Economic Commission for Europe**Inland Transport Committee****World Forum for Harmonization of Vehicle Regulations****Working Party on General Safety Provisions****106th session**

Geneva, 5–9 May 2014

Regulation No. 34 (Prevention of fire risks)**Proposal for the 03 series of amendments to Regulation No. 34
(Prevention of fire risks)****Submitted by the expert from Japan^{*}**

"Model B

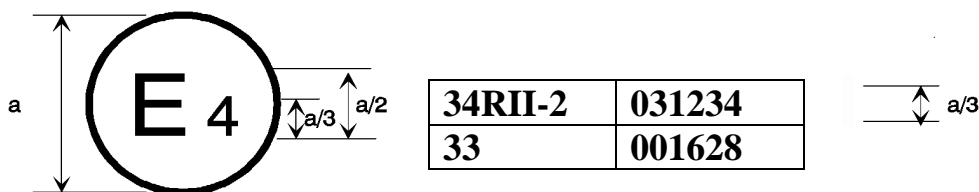
Annex 2, Model B, amend to read:

The above approval mark affixed to a vehicle shows that the type concerned was approved in the Netherlands (E4) pursuant to Regulations Nos. 34 Parts I or IV and II-1 and 33*/. The approval numbers indicated that, at the date when the respective approvals were given, Regulation No. 34 included the 03 series of amendments and Regulation No. 33 was still in its original form.

The above approval mark affixed to a vehicle shows that the type concerned was approved in the Netherlands (E4) pursuant to Regulations Nos. 34 Parts I or IV and II-2 and 33*/. The approval numbers indicated that, at the date when the respective approvals were given, Regulation No. 34 included the 03 series of amendments and Regulation No. 33 was still in its original form."

5. Ad paragraph 3.1.4.2. and Annex 2, Model B: Japan proposes to amend the approval number provisions and approval mark models on the basis of the same justifications as that of paragraph 1.2. in the proposal.

Figure 1

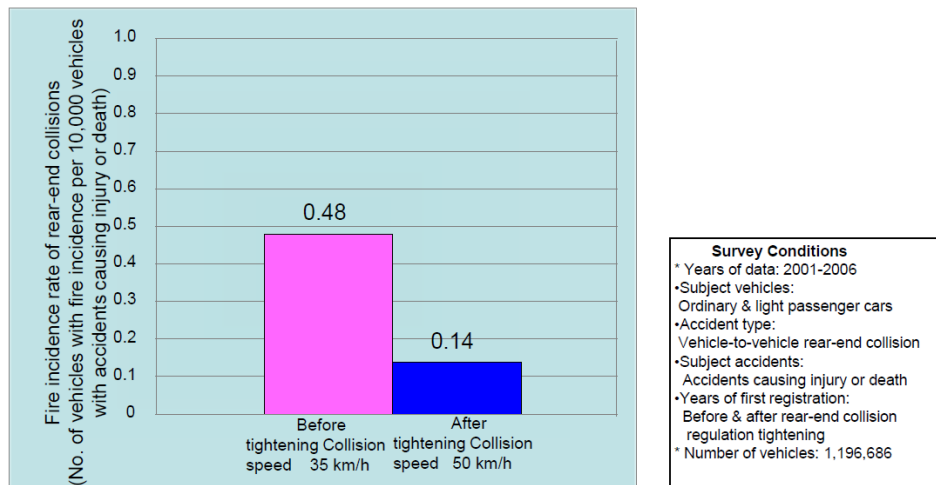
1. In order to prevent fire incidents from rear-end collision on roads such as highways, it is important to conduct rear-end collision tests. Japan has applied the same requirements as the amendments in this document since 1993, resulting in a reduction of one-third in the fire incidence rate (see the Figure 1 below).

4. Figure 1 shows that after the tightening of the rear-end collision regulation in Japan (increased collision speed from 35 km/h to 50 km/h), the fire incidence rate of rear-end collisions has been reduced by about one-third, indicating that the regulatory tightening is effective.

10. Ad Annex 4, paragraph 2.4.2.: Japan believes that the rear collision speed specified in Japan's current safety regulations is appropriate, as the accident data indicate that the fire incidence rate of rear-ended vehicles declined after implementing this measure.
